Comment Set B0012
Powers Engineering

Subject: Powers Engineering Comments on A.06-08-010 Sunrise Powerlink DEIR

**PHASE II DIRECT TESTIMONY
OF POWERS ENGINEERING
ON BEHALF OF BILL POWERS, P.E.**

Figure 1. California Energy Commission Projection of Impact of Varying Levels of Energy Efficiency (EE) on Electric Energy Consumption by California Utilities – Red Line Represents Achievement of 100% of Cost-Effective EE Measures

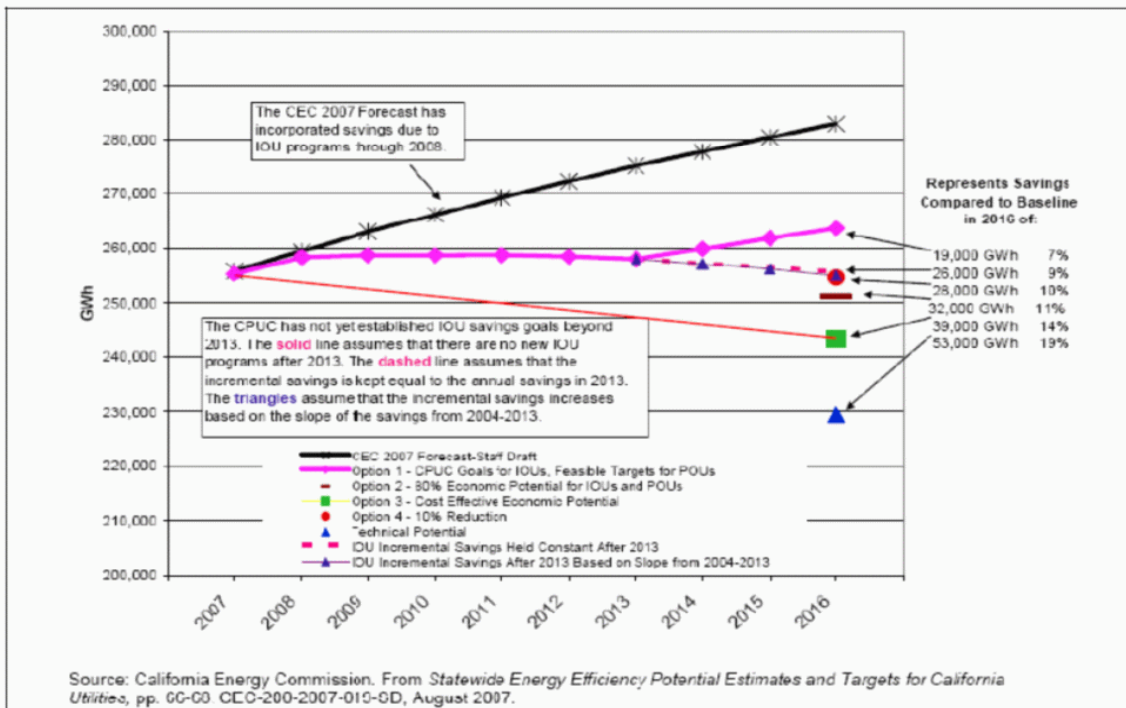
demand decline of approximately 0.5 percent per year over the next decade in SDG&E service territory (See Figure 1 below).

This decline in peak demand would reverse the 482 MW increase in demand by 2016 projected by SDG&E as the reliability justification for the Sunrise Powerlink and convert it into a 280 MW demand decline over the same period. Energy efficiency is the highest priority on the Energy Action Plan loading order. As explained in Attachment B, dozens of cost-effective energy efficiency projects have been carried-out by the City of San Diego with an average absolute reduction of energy use of 20 percent.²¹ The DEIR errs by not including 600+ MW of firm on-peak capacity in the form of energy efficiency. This firm on-peak energy efficiency capacity should also be included in the In-Area Renewable Generation alternative.

Figure 2. 500 kV Interconnection between Sunrise Powerlink and LEAPS lines

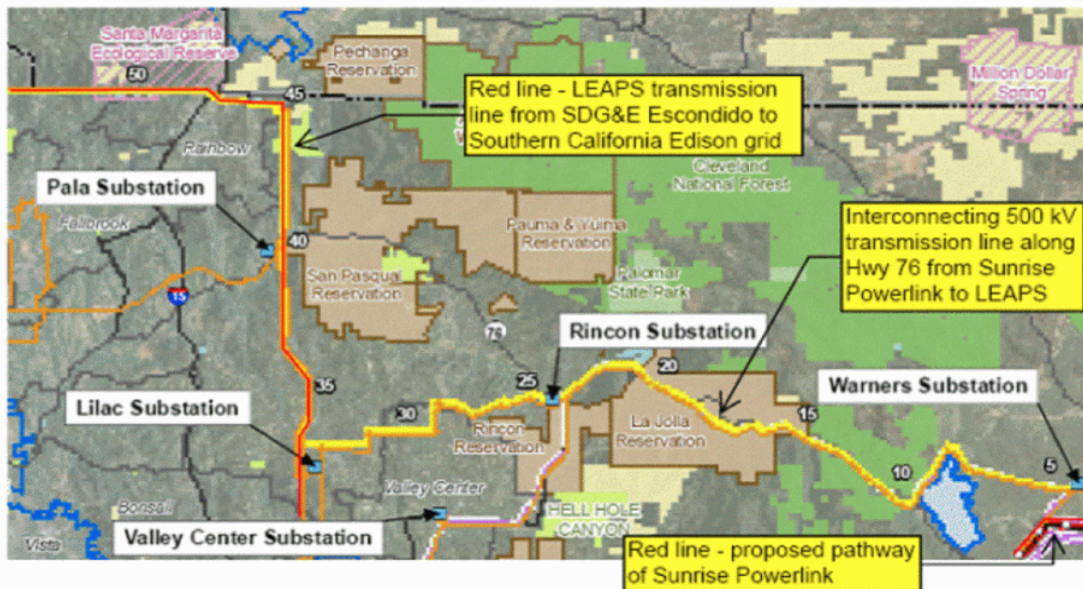
However, the Full Loop described by SDG&E is missing one piece, an interconnection between the Sunrise Powerlink's Central substation near Lake Henshaw and the LEAPS 500 kV substation on Camp Pendleton's northern boundary. The Talega-Escondido 230 kV line is a component of the LEAPS transmission project. This existing 230 kV corridor is only about 30 miles from the proposed Central substation of the Sunrise Powerlink. The interconnecting 500 kV line between the Central substation and the LEAPS 500 kV substation will follow the route of the existing Warners-Rincon 69 kV transmission line along Highway 76, then the existing Rincon-Lilac 69 kV transmission line to the Lilac substation north of Escondido. The 500 kV line would then parallel the existing Talega-Escondido 230 kV line about 30 miles to the proposed Pendleton substation on the 500 kV LEAPS transmission line. The portion of the 500 kV interconnection route passing through or by Indian lands along Highway 76 is shown below in Figure 2 (map extracted from Figure B-12b, DEIR, p. B-30, tags added by B. Powers).³⁹

The failure of the DEIR to include an environmental analysis of this 500 kV interconnection between the Sunrise Powerlink Central substation and the proposed Pendleton substation on the 500 kV LEAPS transmission line is a critical omission.
